ADDENDUM #1- April 15, 2026

CITY OF LAFAYETTE

2026 Road Paving Project Project Number 014-9745

Subject: Geotechnical Memorandum
2026 City of Lafayette Pavement Project
Springhill Road,
Lafayette, California

1 TYPICAL DETAIL
 SCALE: 1"=2'

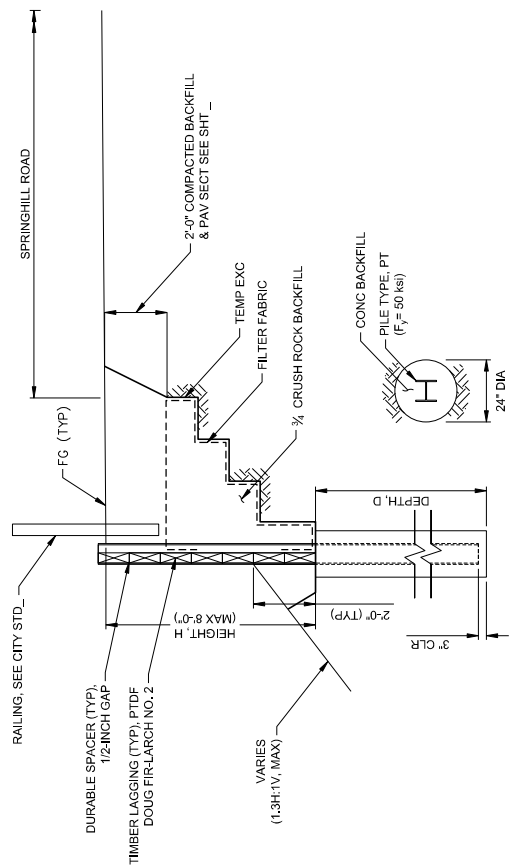
The results of our analyses are summarized in Table 1 and on a typical section for the wall attached as Figure 1.
